Planning Commission Staff Report

Project Type: Amended Site Development Section Plan

Description: **The Reserve at Chesterfield Village (Phase One)**: Amended Site Development Section Plan and Amended Architectural Elevations for a 28.13 acre lot of land zoned R-5 and R-8 Residence District with a “PEU” Planned Environment Unit located at Baxter Road south of the intersection with Wild Horse Creek Road.

Condominium Homes—Front Elevation

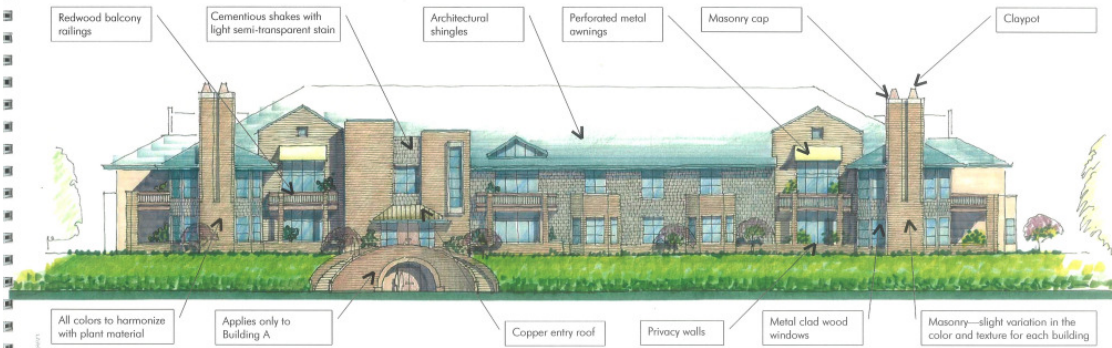
Staff has reviewed the proposed amendment to the elevations and feels that it is compatible with the approved elevations and materials. The original intent of the project was to have exterior colors which would identify each housing type with a color palette that was selected to provide an overall theme for the development.

AMENDED SITE DEVELOPMENT SECTION PLAN
REVISED 11-2-2009
10-20-3009
10064-0
PHASE 1

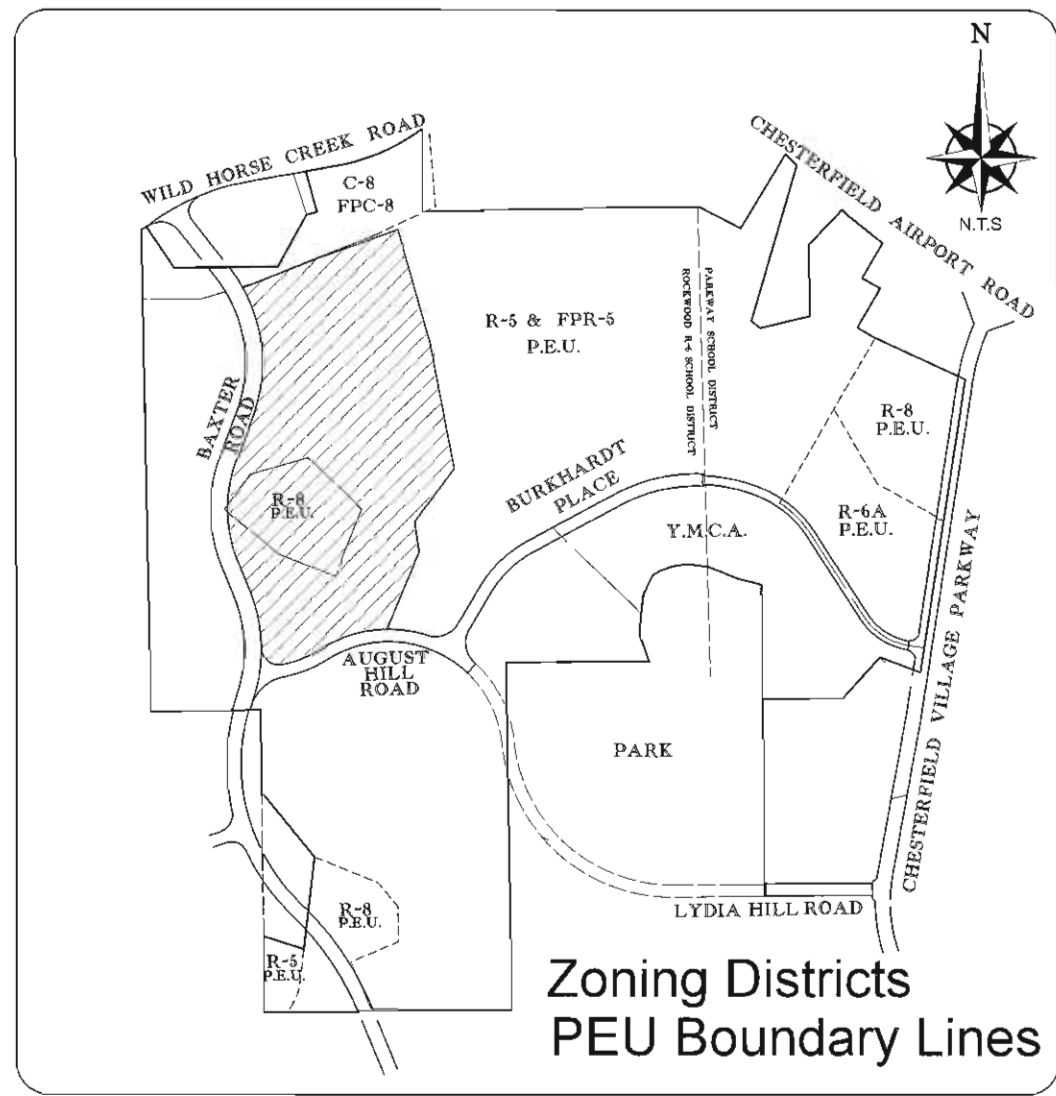
Volz, Inc., on behalf of Gunhay, LLC has submitted a request for a Amended Site Development Section Plan and Amended Architectural Elevations. The request is to amend twenty-six of the lots to have single-family detached homes that were previously approved as single-family attached homes. Due to the change from the attached model, the elevations of the proposed new detached units have amended architectural elevations.

- Zoning**
 The subject site is currently zoned “R5” and “R8” Residence District with a Planned Environment Unit and was reviewed against its requirements and all applicable Zoning Ordinance requirements. The site adheres to the applicable Zoning Ordinance requirements. The new lots will have to meet the side yard setback for the single-family detached structures.
- Open Space**
 The Open Space in the development will not be changed due to the proposed housing type change.

Staff has reviewed the submittal and has found the application to be in conformance with the Comprehensive Plan, Zoning Ordinance and the site specific ordinance.
